## SERVICE INFORMATION NO. SI36-042

ATA Code: 73  
Checking and Replacement of Flexible Fuel  
Line

## **OF FLEXIBLE FUEL LINE**

### **SB-912-054**

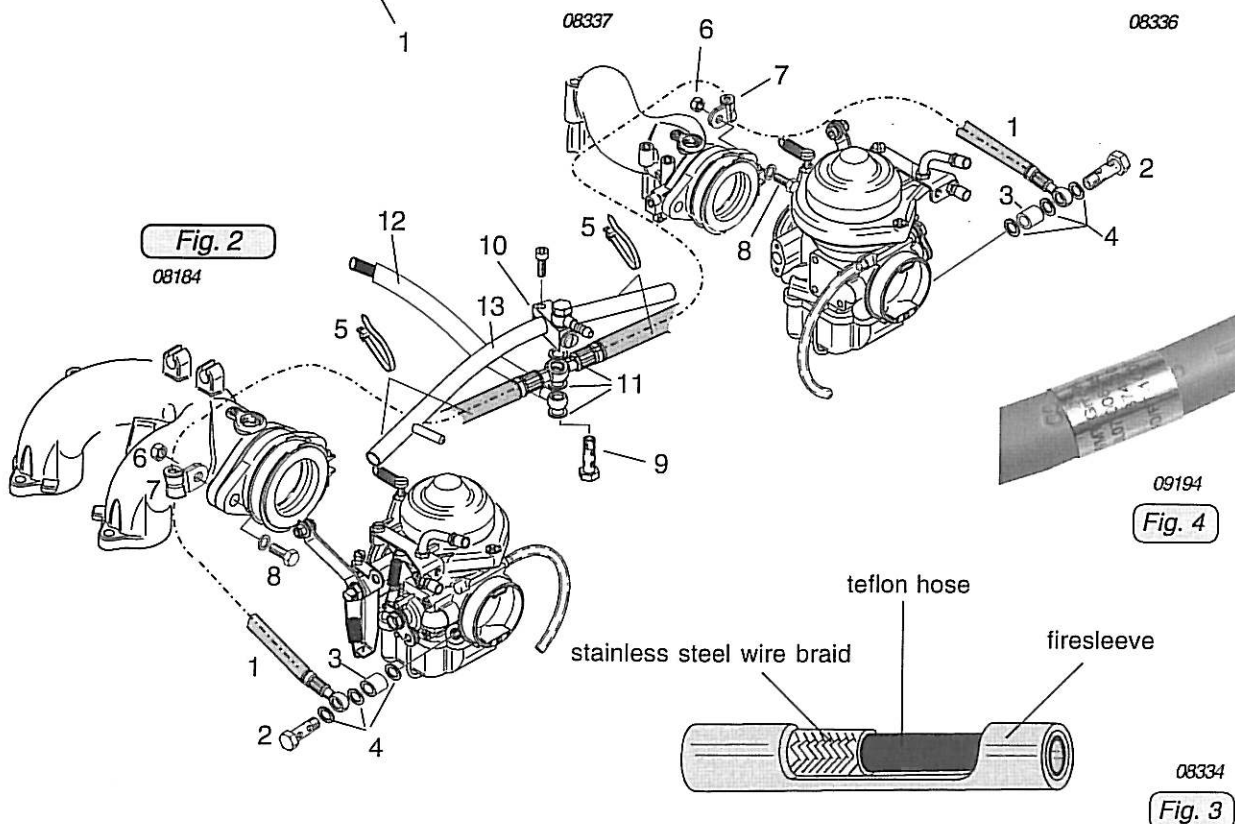
Visual inspection of the fuel line (1) in the area clamp (7) and both ends of the yellow protection cover. (see Fig. 1)

◆ **NOTE:** A possible crack can be observed by careful bending of the fuel line. If you notice cracks or porosity then you need to replace the fuel line in accordance section 3.1.2.

2. Install both cable clamp (7) in accordance with Fig.1 on the fuel line.

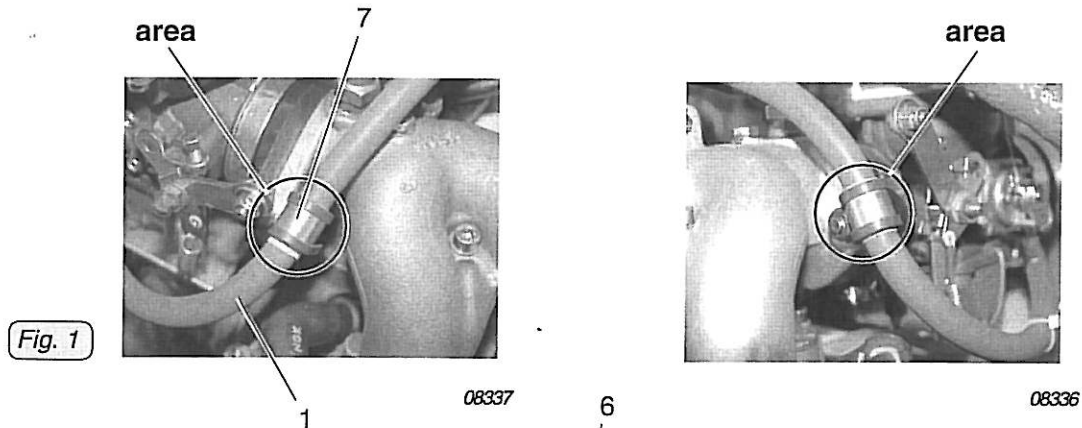
(see Fig. 2)

1. Unscrew the banjo bolt (2) with distance sleeve (3) and 3 gasket rings (4).

2. Cut the cable tie (5).

3. Remove hex. nuts M8 (6) together with clamp (7). Held in place by hex. screw (8).

4. Remove banjo bolt (9) from clamp block (10) together with 3 gasket rings (11).

◆ **NOTE:** The gasket rings 8x13 (4), used on the banjo bolt of the carburetor, are of different thickness compared to the gasket rings (11), used on the banjo bolt of the clamp block.

5. Remove the fuel line (12).

1. Install flexible fuel line (1 and 12) and the banjo bolt (9) with new sealing ring (11) on the clamp block (10). Tightening torque of banjo bolt (9) 10 Nm (90 in.lb). Check that the fuel lines are not under strain or tension.

3. Install the fuel line (1) with distance sleeve (3) and sealing ring (4) on the carburetors.

Tightening torque of banjo bolt (2) 10 Nm (90 in.lb). Place cable clamp (7) into position.

4. For proper support. Install the clamp (7) and hex. nut M8 (6) with LOCTITE 221. Tightening torque of hex. nut (6) 15 Nm (133 in.lb).
